STATE OF HAWAII
DEPARTMENT OF TRANSPORTATION
HIGHWAYS

ADDENDUM NO. 2
FOR
SEISMIC RETROFIT, HALEAKALA HIGHWAY ROUTE 377,
WAIALE GULCH, ALAE (NAALAE GULCH),
AND PULEHU GULCH (POHAKUOKALA) BRIDGES
DISTRICT OF MAKAWAO, ISLAND OF MAUI
FEDERAL-AID PROJECT NO. STP-0377(008)

October 21, 2026

OPTIONAL COUPLING DETAIL

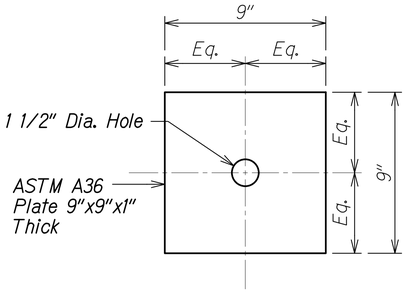
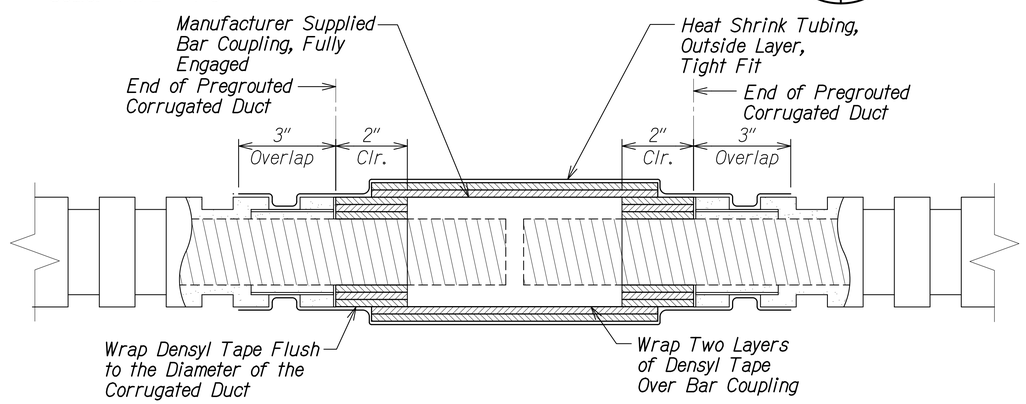
2. **Detail 1 of Sheet No. S1.1 shows a min. 8" diameter drilled hole for the soil nails. a. Due to the limited access of the drilling locations and adverse subsurface conditions, it's unlikely a small drill rig that can access the drilling locations will be able to drill 8" diameter holes through gravels, cobbles, and boulders. Are 6" diameter holes allowable? 6" diameter drilled holes are much more typical for soil nails and can be drilled with smaller equipment.**

4. **The soil nails will need to be shipped in shorter sections and coupled in the field. a. Can a coupler detail be provided?**

DATE	REVISION
10/9/26	1 Add. 2 - Added Detail

It is acceptable to couple soil nails in the field. A coupler detail will be provided on Plan Sheet ADD. 56 Typical Soil Nail Details in Addendum No. 2.

WAIALE GULCH BRIDGE BENT NO. 1
DEMOLITION PLAN AND SECTIONS

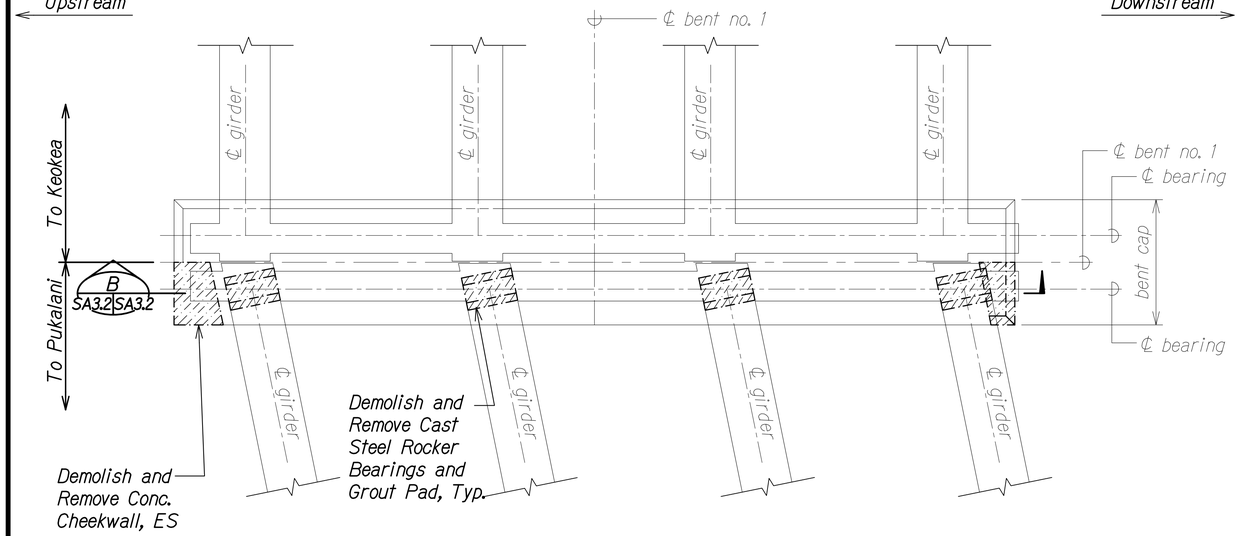
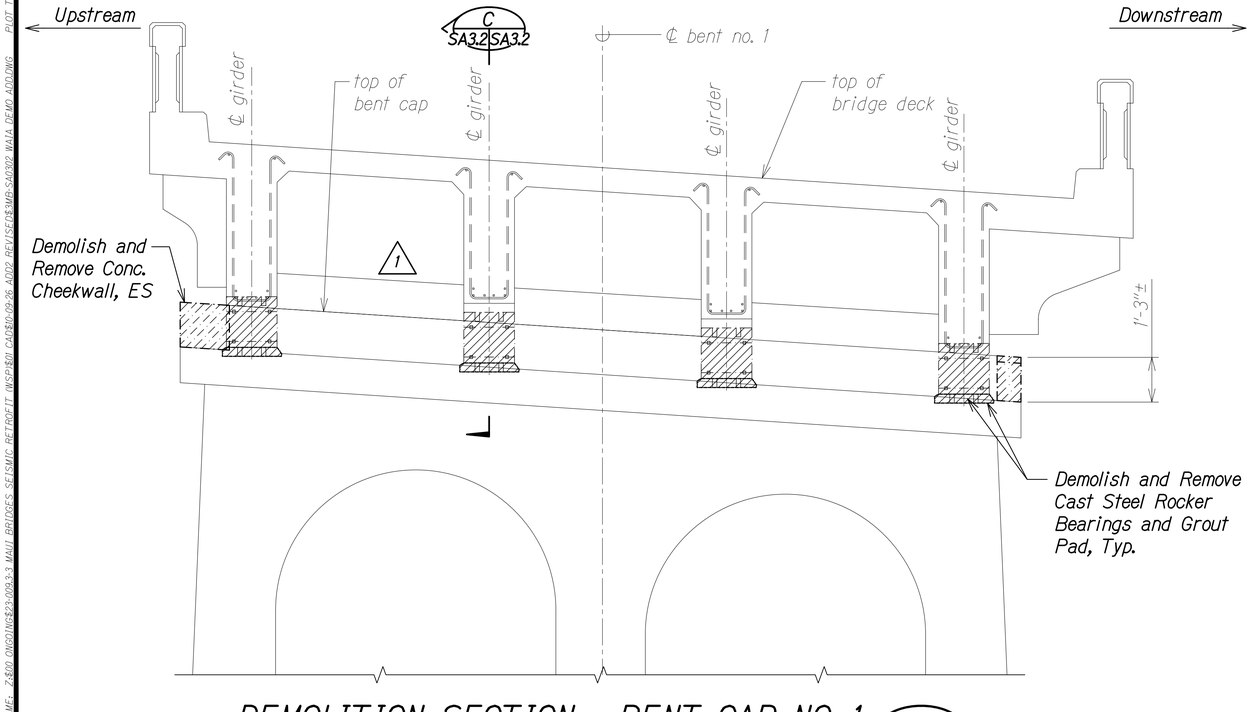
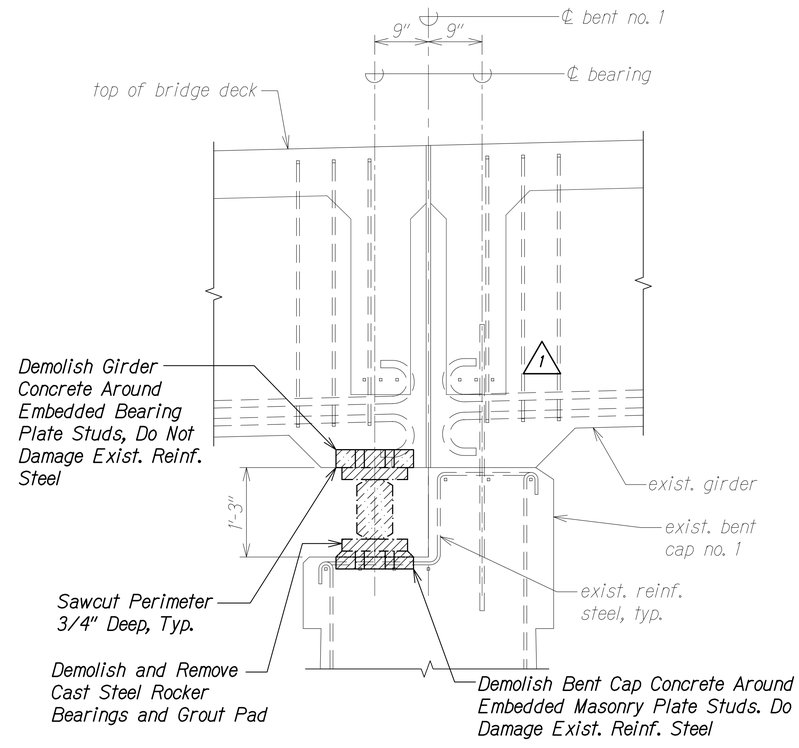
DATE	REVISION
10/9/26	1 Add. 2 - Rvsd. Linework

14. **Shts. SA3.2, SA3.9, SA3.10, SA3.15; SP 202.03(E) - The Waiale bent construction sequences require concrete repairs on the bottom of the girders and top of the bent caps at the bearing seats, and Sheet SA3.2 makes this patching incidental to the lump sum Removal of Existing Bearings. These surfaces cannot be observed until the cast steel rocker bearings and grout pads are removed. Please state the repair area and depth bidders should include in the lump sum, and confirm that deterioration beyond that extent (including section loss of existing reinforcing) will be paid as extra work.**

The extents of the demolition in both plan and depth are based on the intent of removing the existing cast steel rocker bearings and grout pads. Please see record as-built plans for dimensions and details of rocker bearing, including the dimensions of the concrete embedded bearing/masonry plate studs. No corrosion or section loss in existing reinforcing steel at these locations is anticipated.

WAIALE GULCH BRIDGE
BENT NO. 2 PLAN AND SECTIONS

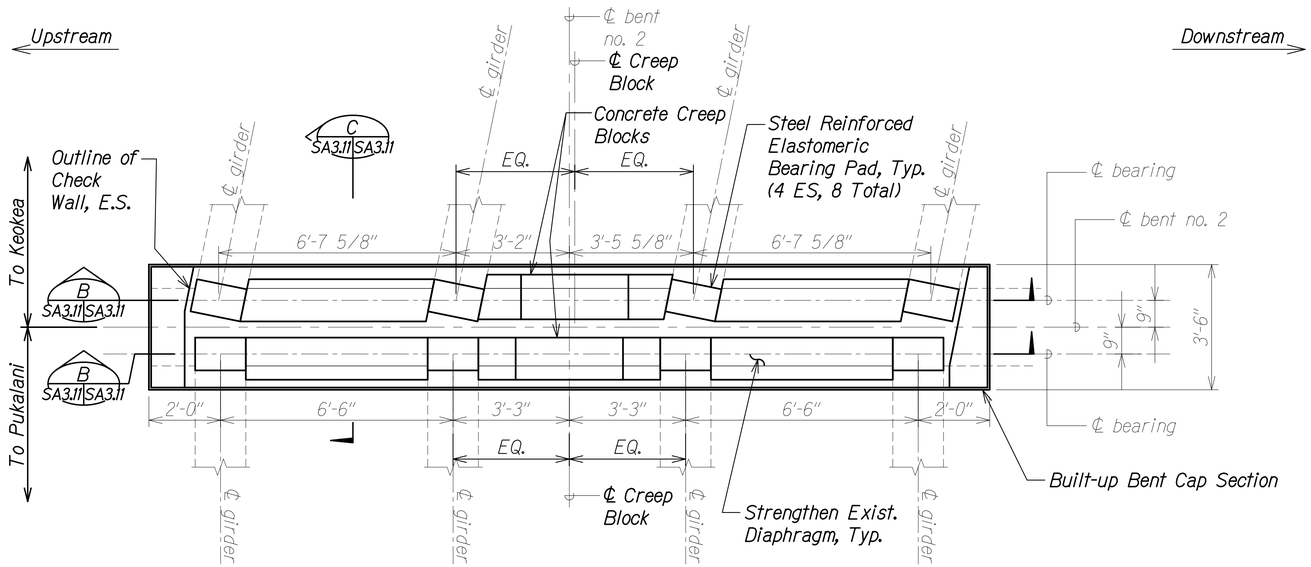
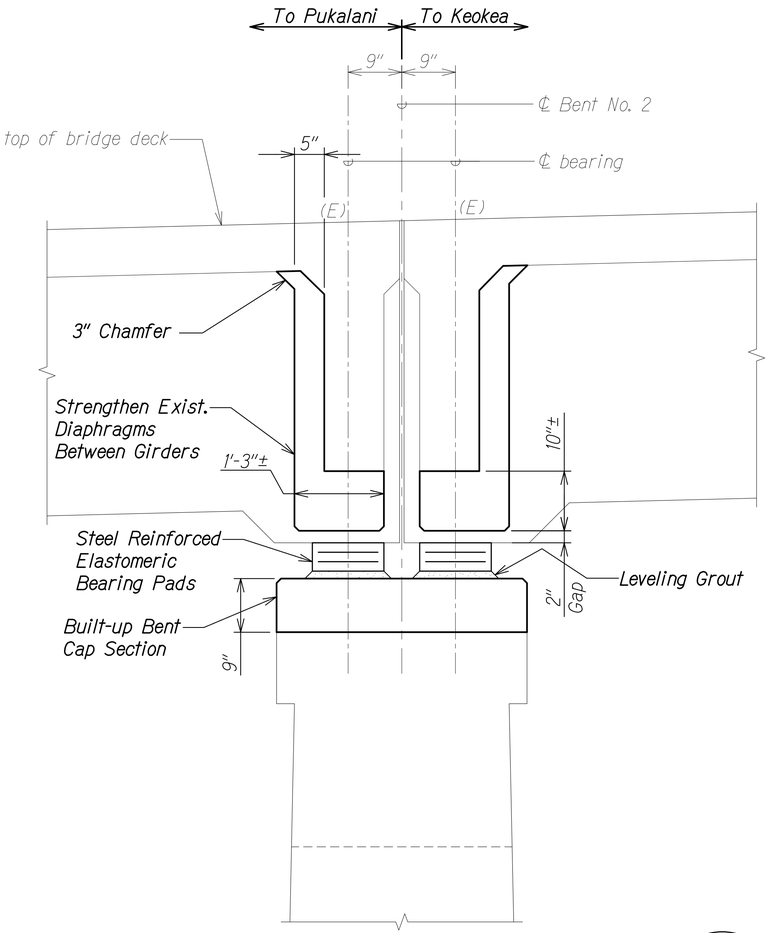
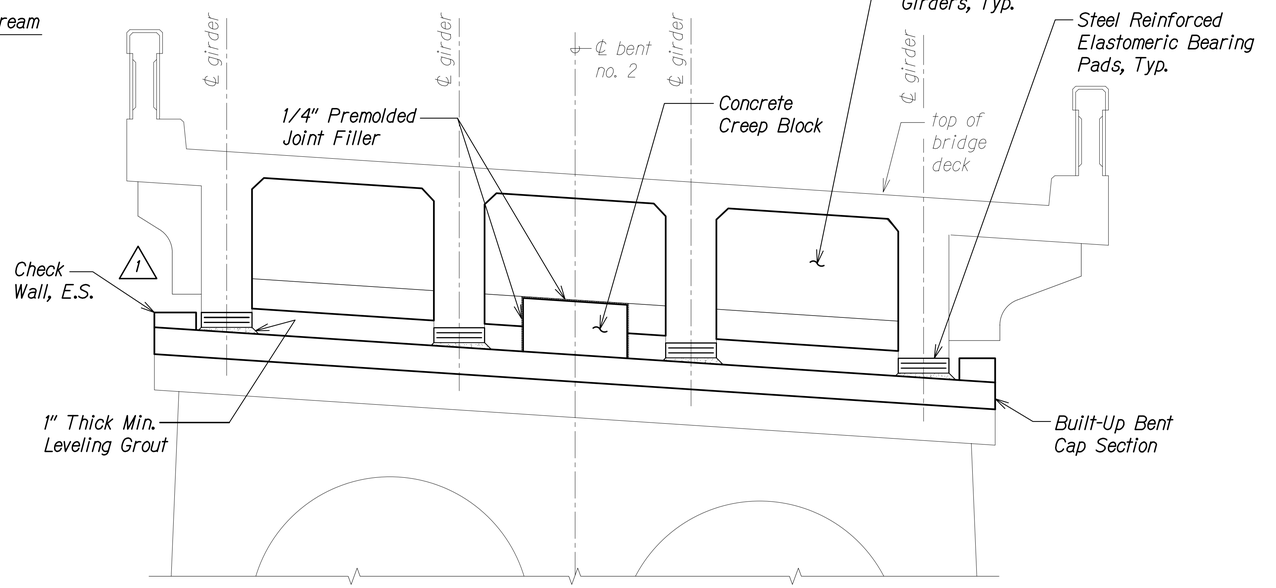
DATE	REVISION
10/9/26	1 Add. 2 - Revised Cheek Wall Height

⚠1 BENT NO. 1
CFRP STRENGTHENING DETAIL OF TIE BEAM (A)

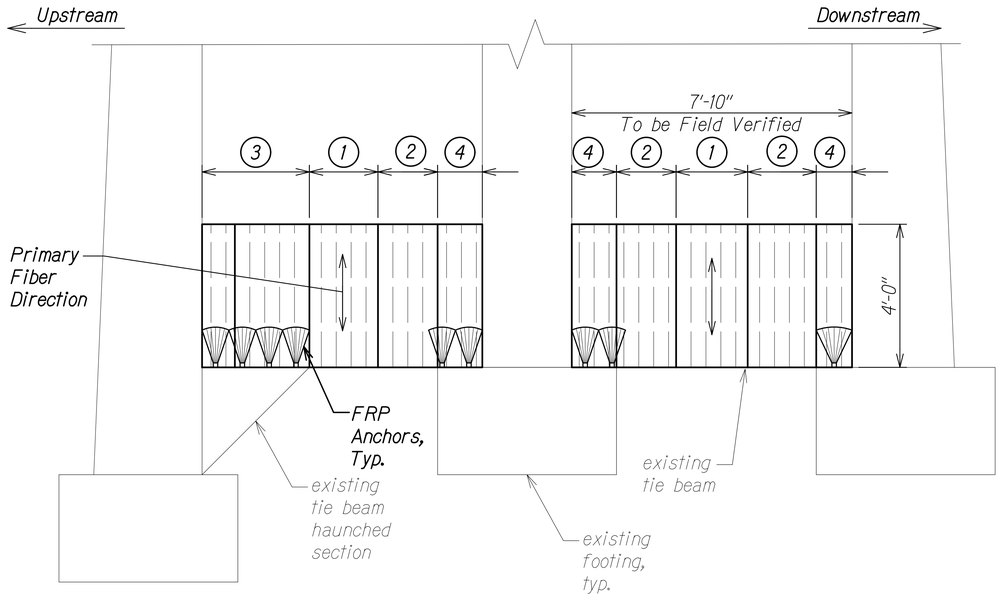
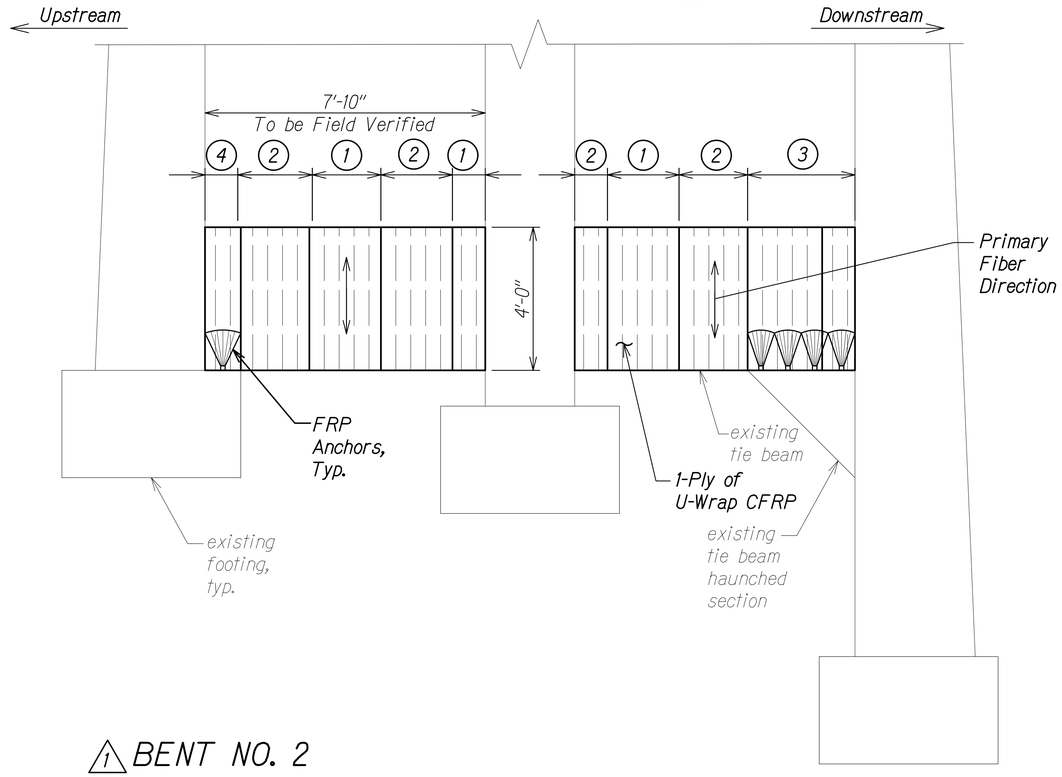
16. **SP 577.03(C)(1)-(2); Shts. SA3.16-SA3.17 - SP 577.03(C) requires repair of all damaged or defective concrete and pressure epoxy injection of cracks wider than 0.010 inch before CFRP is applied, and the tie beam dimensions on Sheet SA3.16 are "To be Field Verified." The CFRP items are lump sum and there is no item for substrate repair or crack injection. Please provide the estimated spall repair (square feet and depth) and crack injection (linear feet) to include in the lump sum, or add unit-price or force account items. Please also confirm that tie beam dimensions that differ from the plans will be adjusted under Std. Spec 104.06(3).**

Existing dimensions are always to be field verified by the Contractor. Contract plans show dimensions of tie beam elements. Additionally, as-built plans are available, so the Contractor is able to obtain the geometric quantities necessary for bidding. The Contractor can use zero square feet of spall repair and zero linear feet of crack injection repair for lump sum bid price. Tie beam dimensions that differ from the plans may be adjusted under Std. Spec 104.06(3) or any of the other methods that apply and as mutually agreed upon by all parties.

⚠1 STRUCTURE EXCAVATION PAY LIMITS SECTION (E) SA3.17 | SA3.17
Scale: 1" = 1'-0"

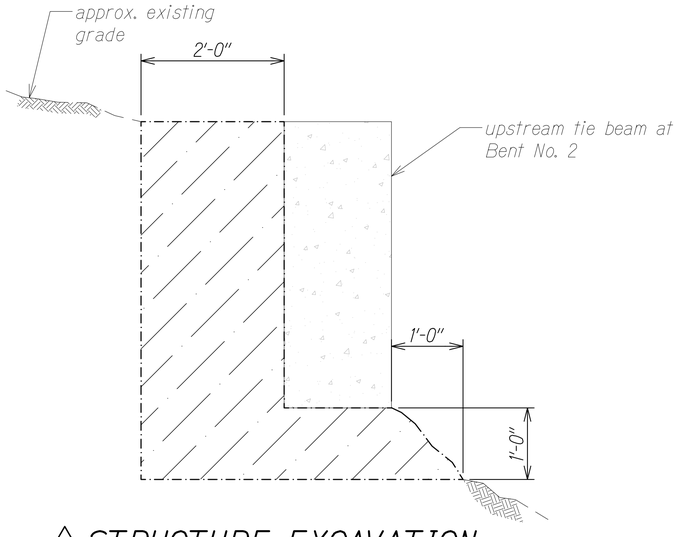
c) The Upstream side Tie Beam at Pier 2 for Waiale Stream Bridge is the only tie beam location that requires soil excavation in order to perform the CFRP work. A pay item for this work will be created for in the proposal schedule. Excavation pay limits will be included on sheet SA3.17. Any excavation work outside of the prescribed pay limits will be at the Contractor's discretion and cost.

PLAN - CRM AT ABUTMENT NO. 2

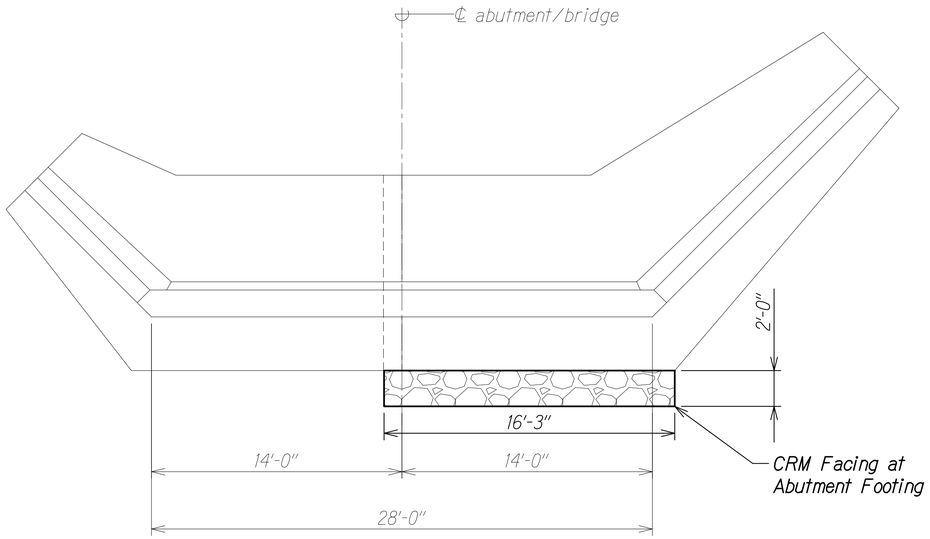
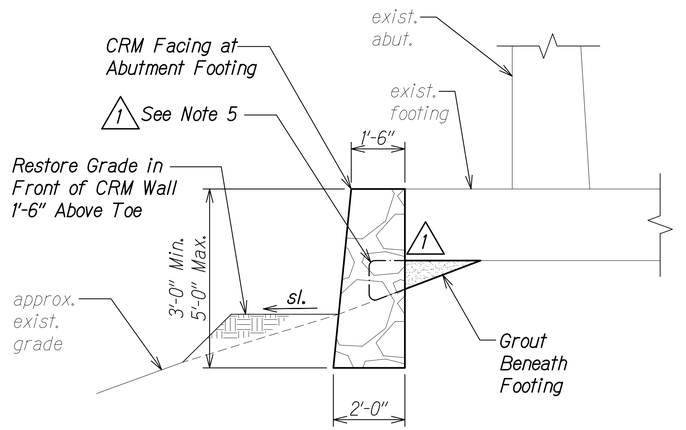
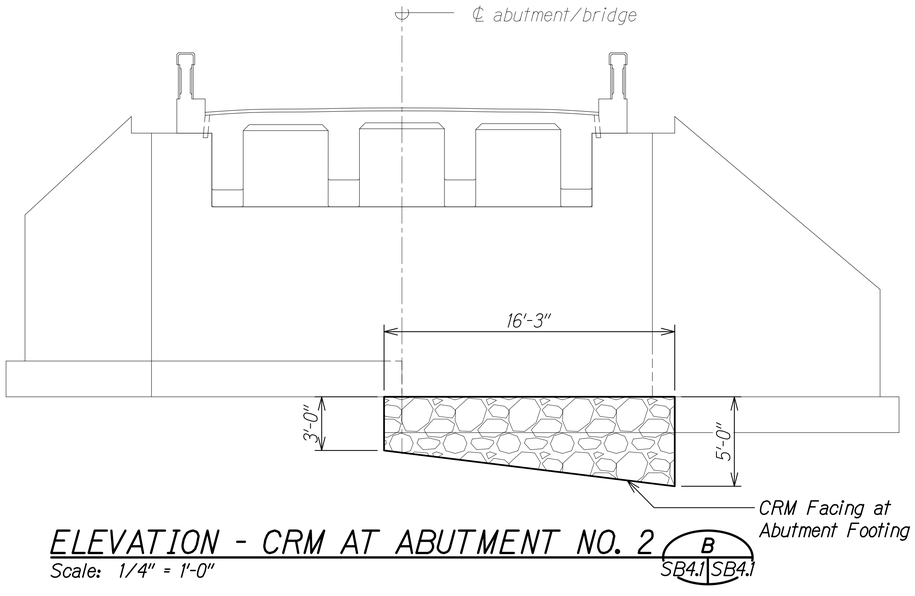
18. **Shts. SB1.1, SB4.1, SB5.3, C-2; Item 508.1000 - Sheet SB4.1 makes grouting of the voids beneath the Alae Abutment No. 2 footing incidental to lump sum Item 508.1000 Cement Rubble Masonry. The void extent is known only from the June 4, 2024 inspection shown "For Reference Only" on Sheet C-2 and may have enlarged since. Please provide the estimated grout volume to include in the lump sum, and confirm that grout required beyond that volume will be paid as extra work. Please also clarify whether the Abutment No. 1 footing undermining listed in the Sheet C-2 defect table is part of the scope.**

DATE	REVISION
10/9/26	1 Add. 2 - Added Notes

Grout quantity for void extent will be addressed on Plan Sheet ADD. 102 Alae Bridge Abutment No. 2 Erosion Protection Details as part of Addendum No. 2.
